SUBJECT: LICENSEE'S 10 CFR 50.59 EVALUATION OF MAIN STEAM LINE BREAK
(MSLB) REANALYSIS AND EFFECT ON ISOLATION VALVE CUBICLE
(IVC) AND REACTOR CONTAINMENT BUILDING (RCB)
(TAC NOS. M98914 AND M98915)

Originating Document No. USGE 95-0013Revision No. 0TITLE CN-1462 Revise analysis of the Main Steam Line
Break in the IVC and PCB

TITLE MSLB Blowdown Model for IVC

Change Number 1962 Date 3/29/95
 Originator Charles Albany Dept NPLA
 Change Description Main Steam Line Break in IVC

Figure 3.6.A-3

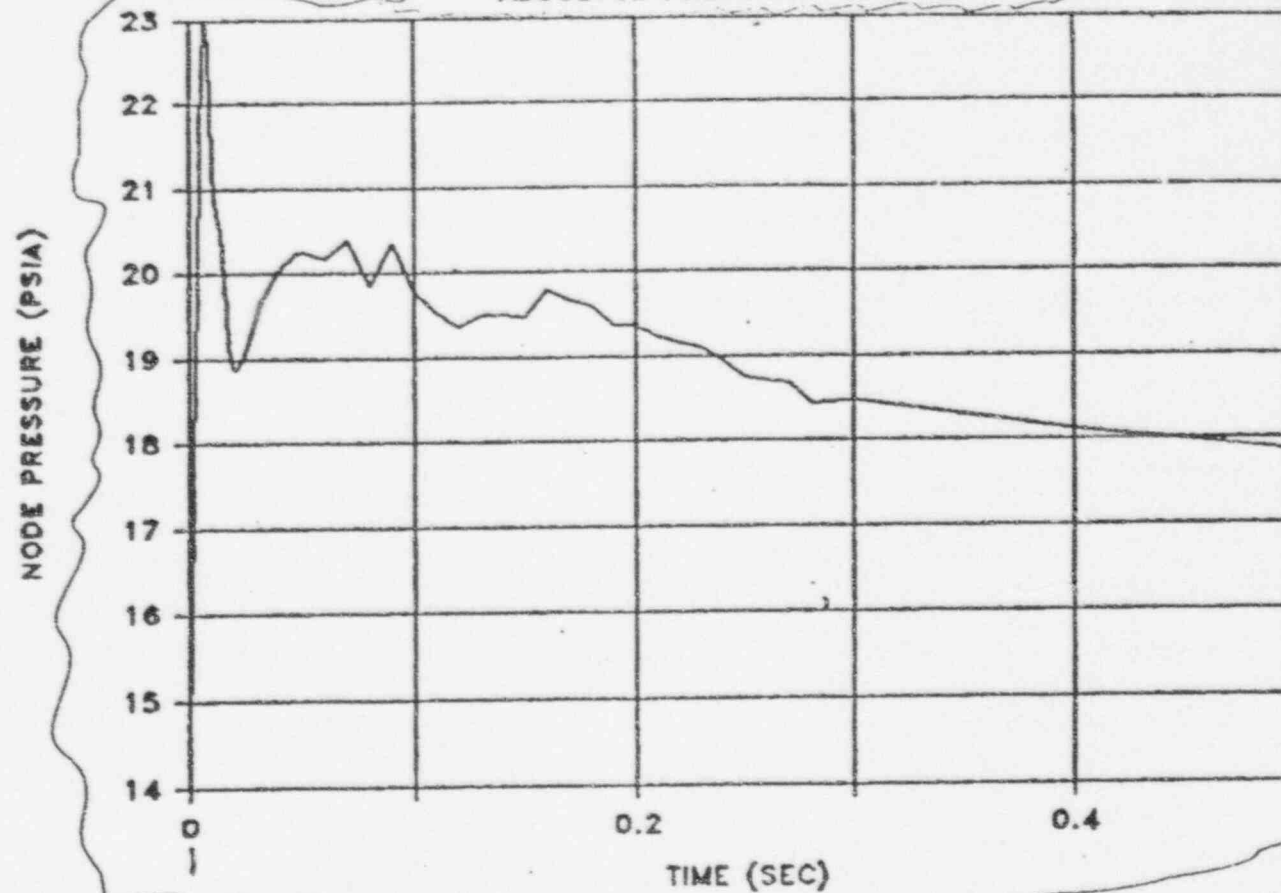
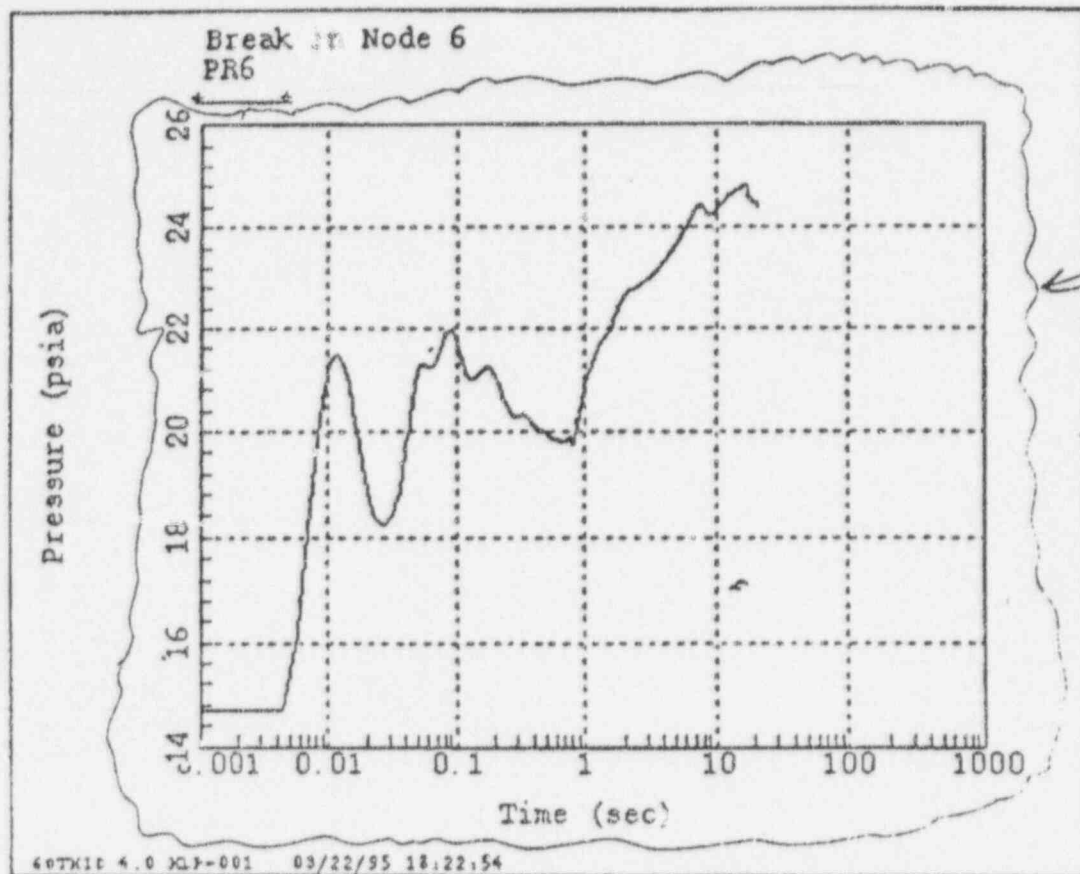
Replace with attached Figure

← Figure 6

Figure 3.6.A-3

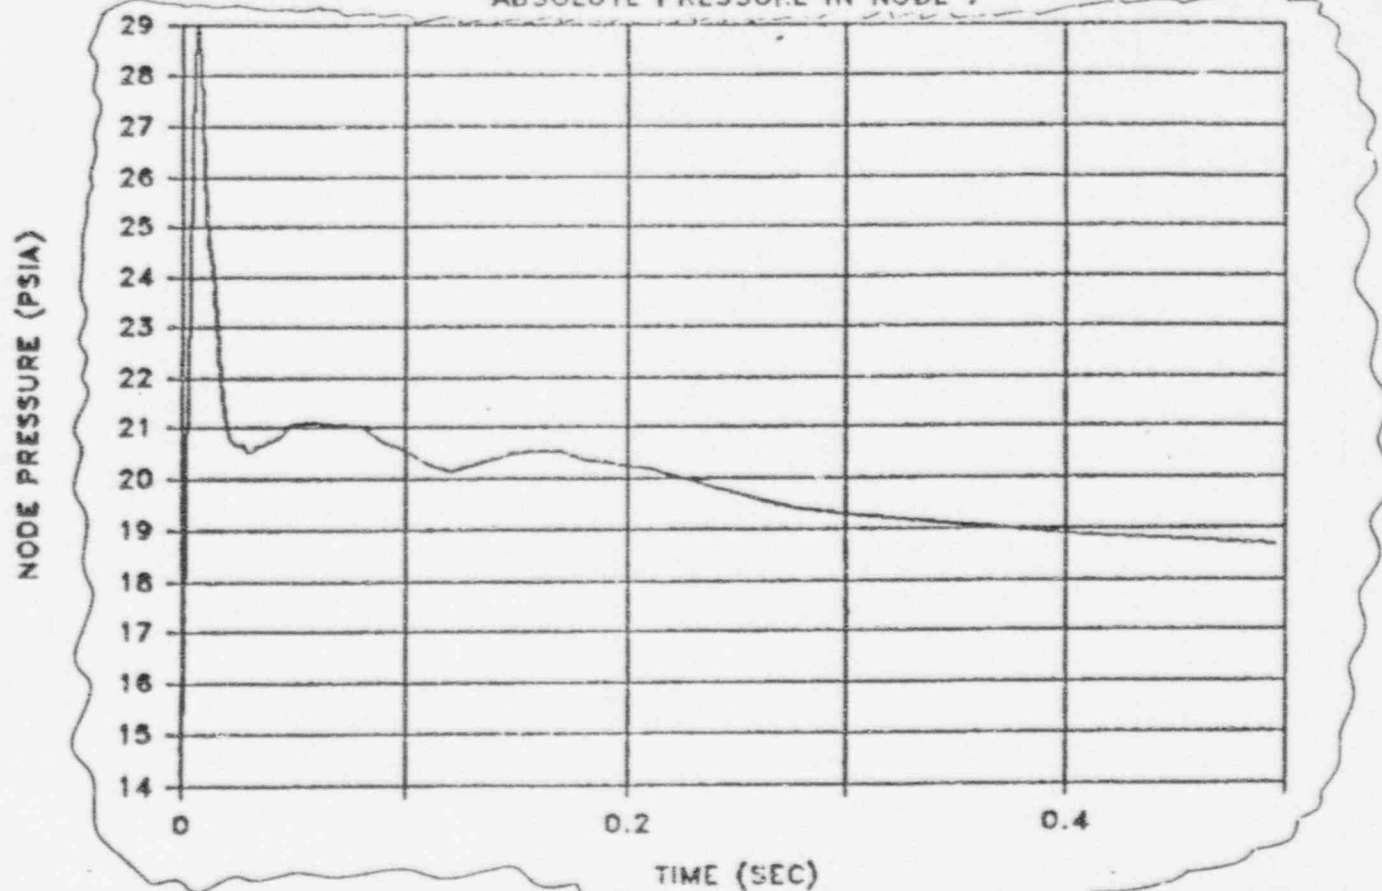
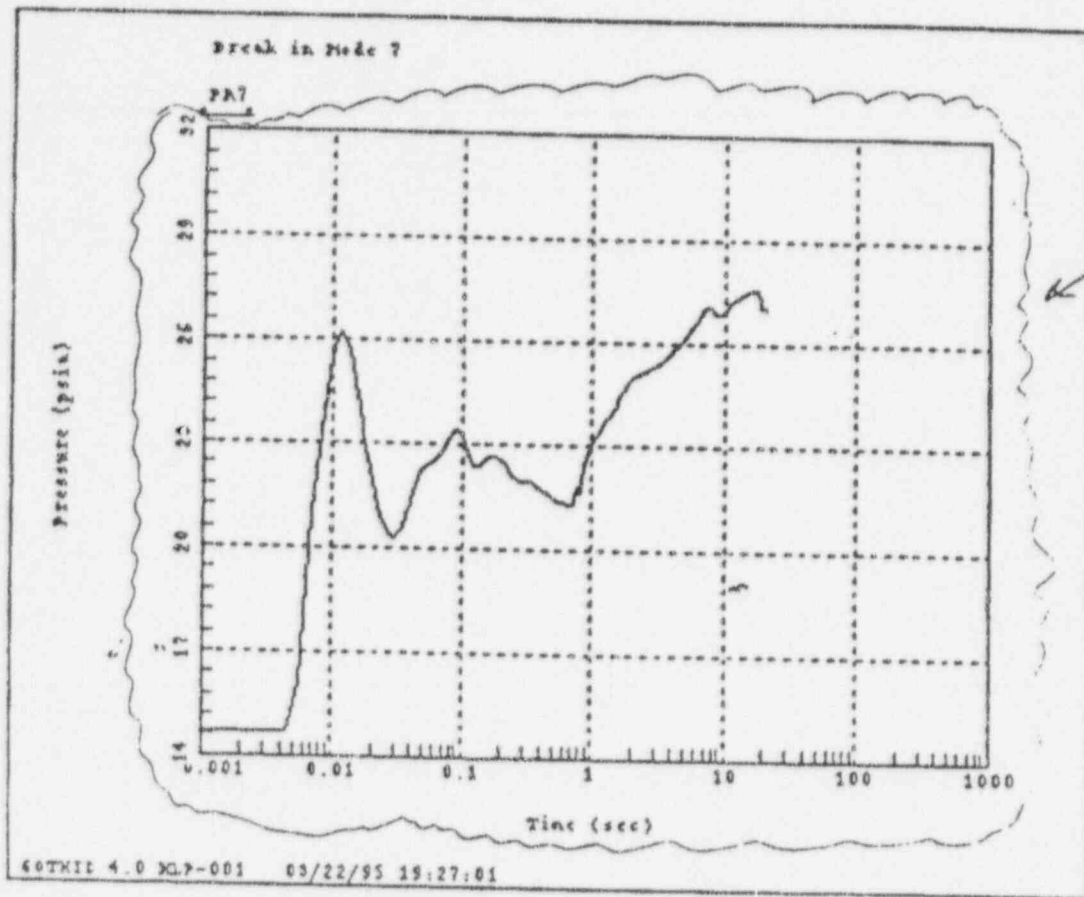
Replace with Attached Figure 7

Figure 7

Figure 3.6.A.3

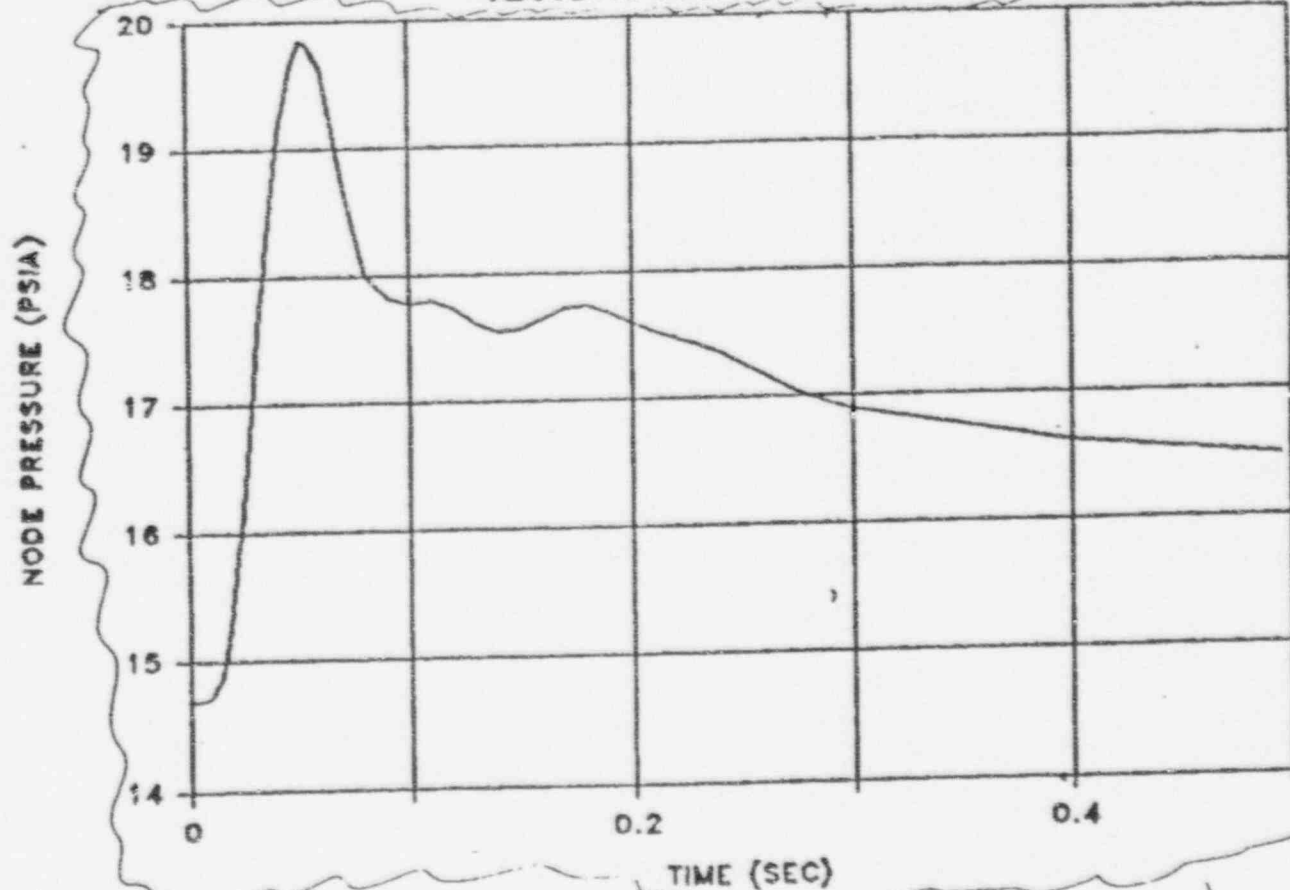
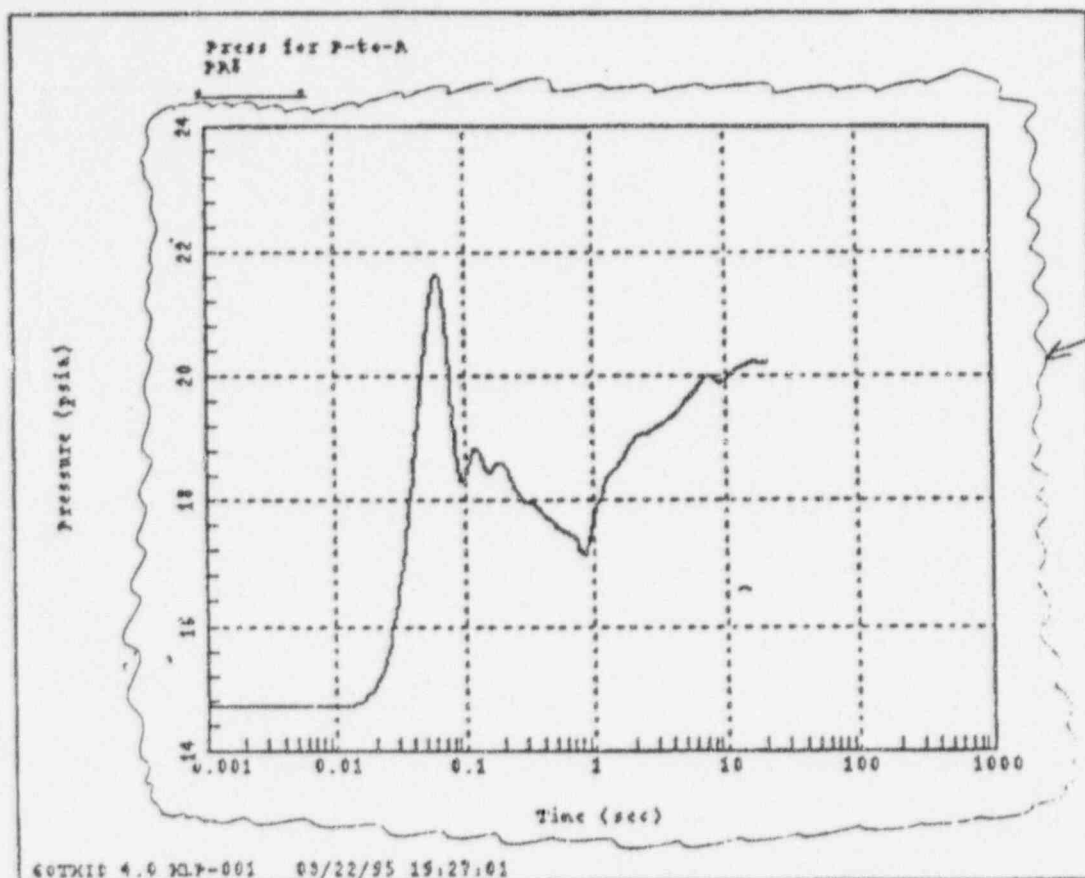
Replace with attached Figure B

Figure 8

Figure 3.6.A-3

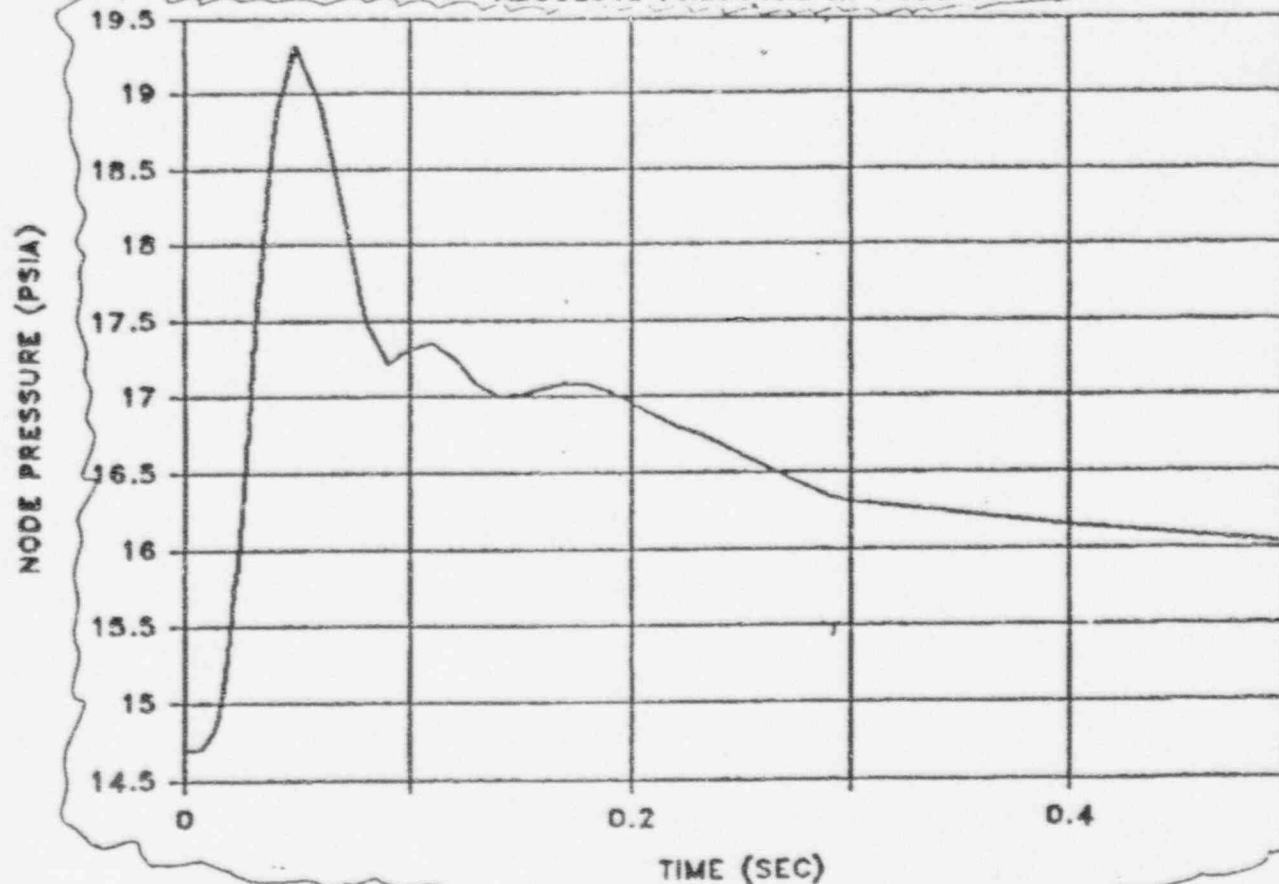
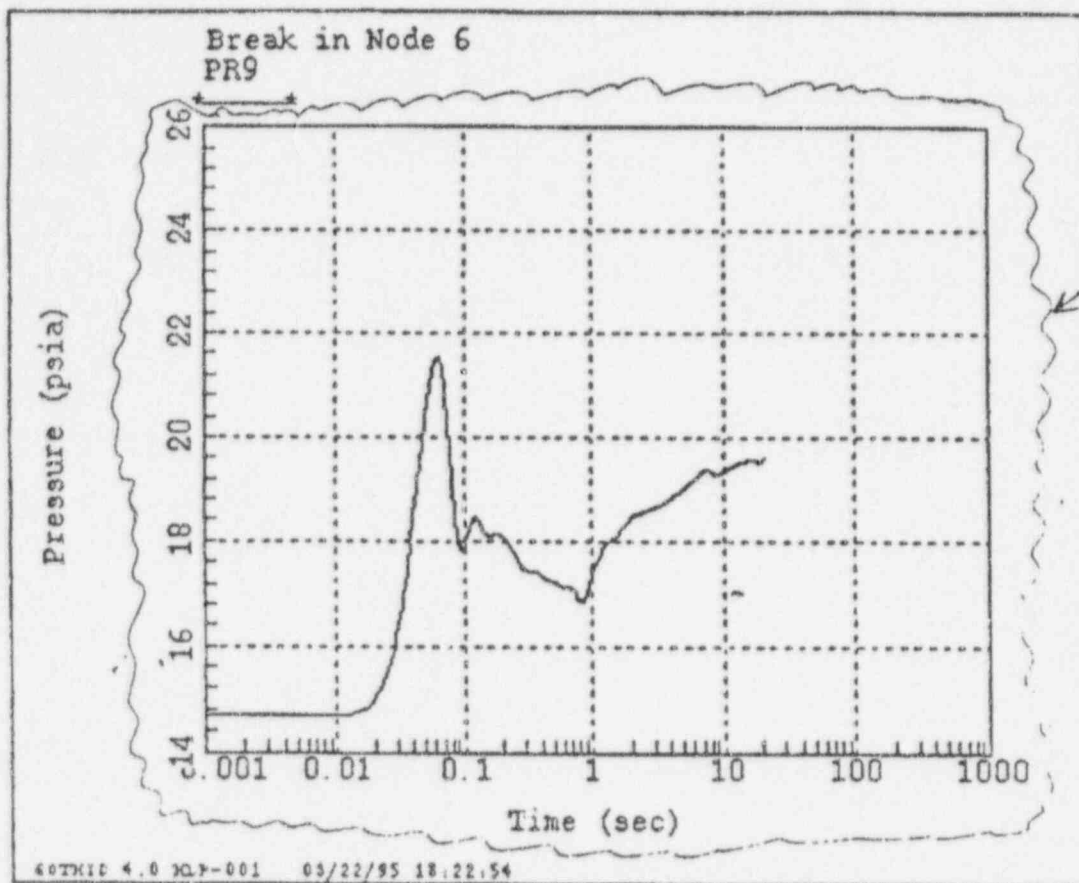
↑ Replace with attached Figures

Figure 9

Figure 6.2.1.2-25

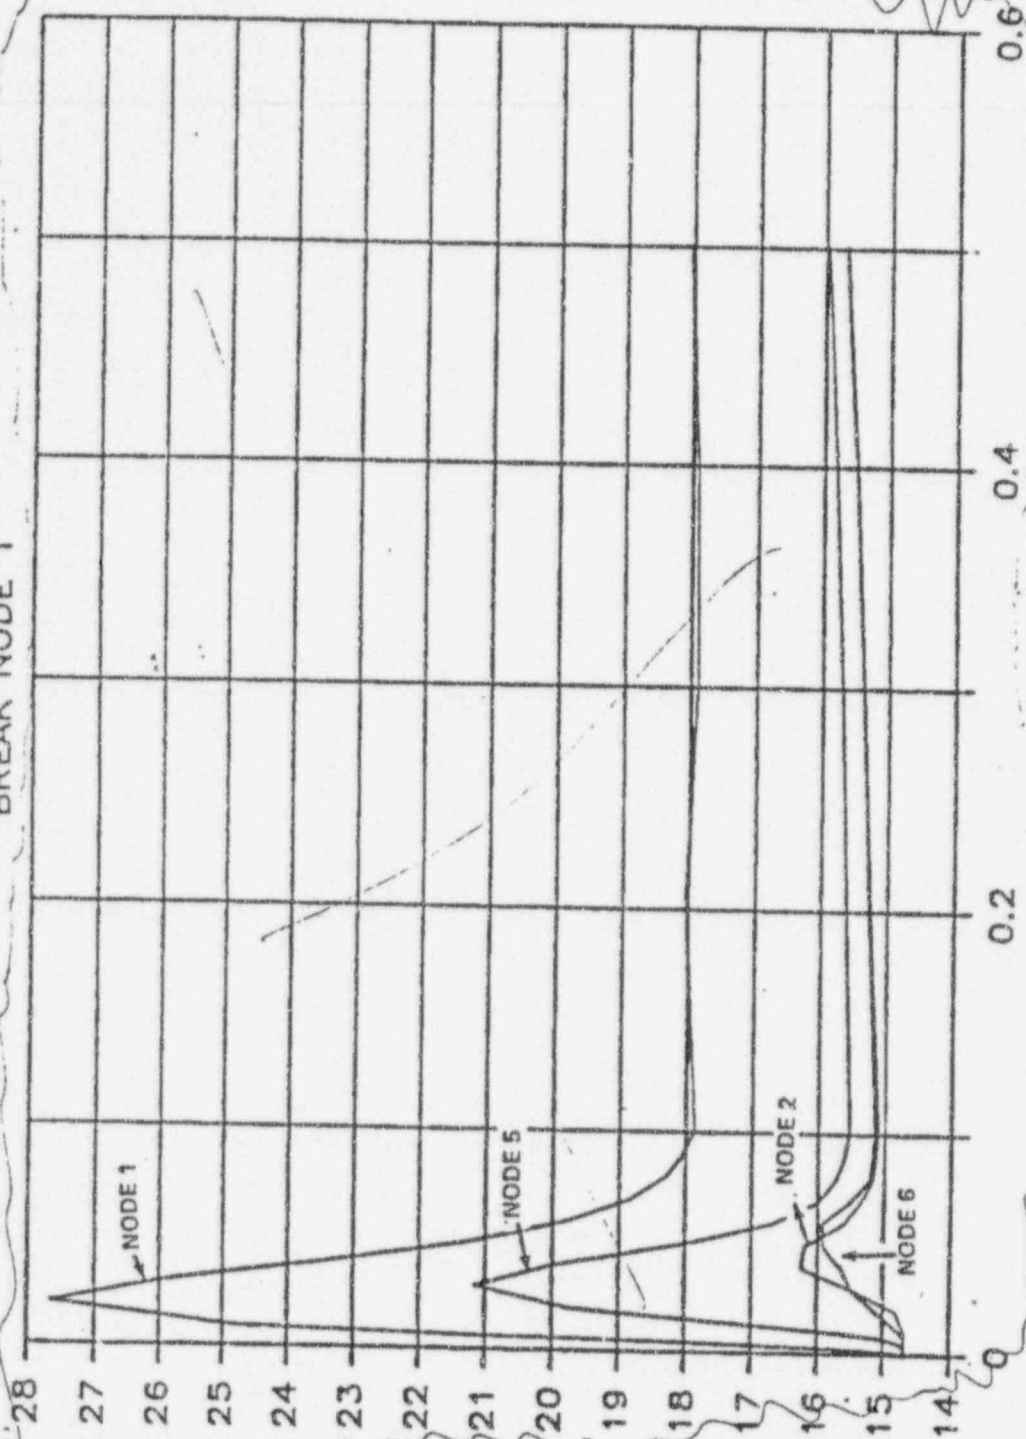
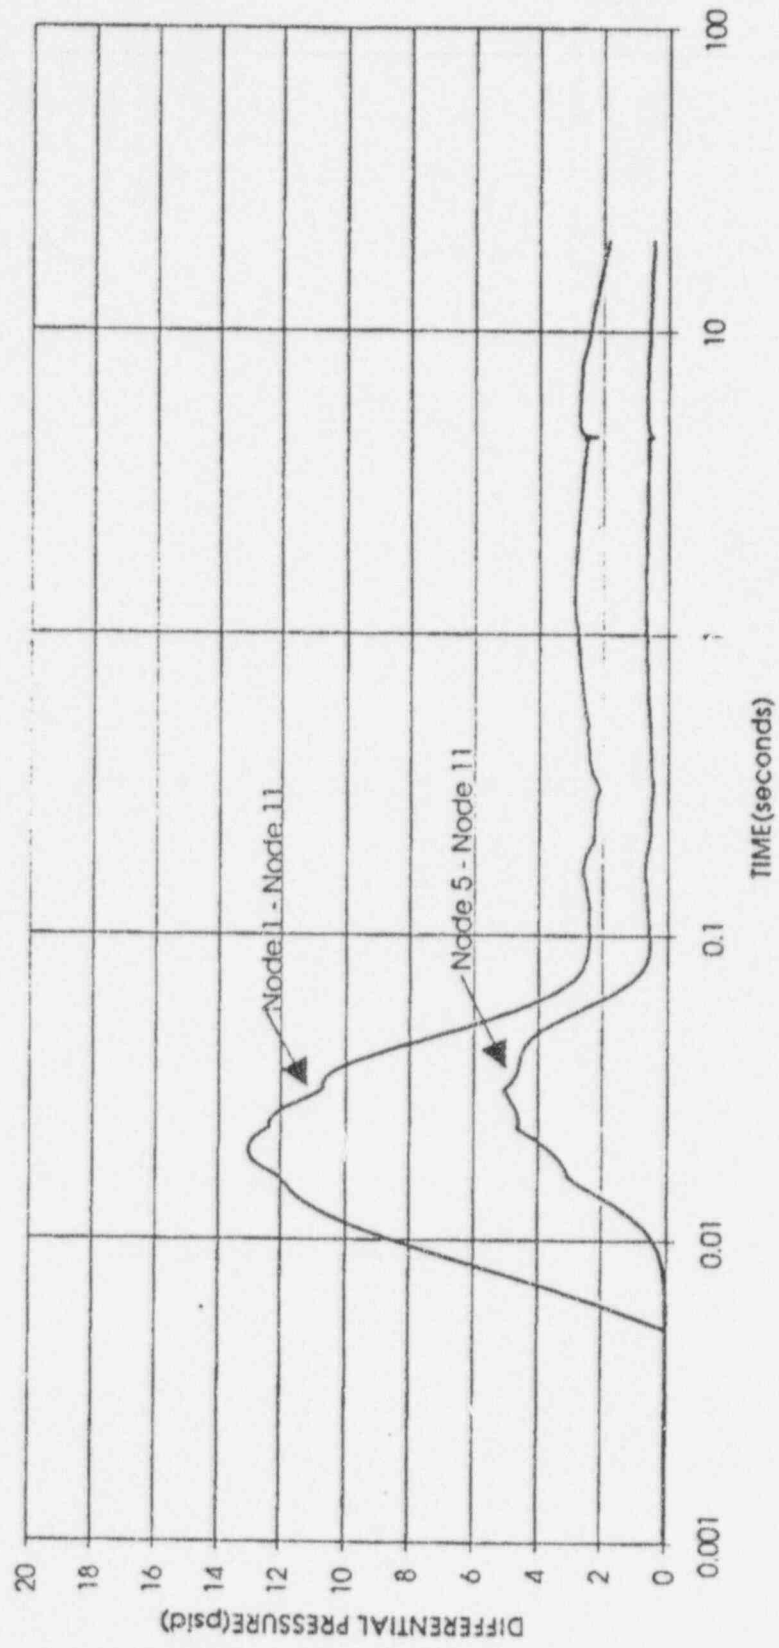
Replace with attached
Figure C A

Figure A
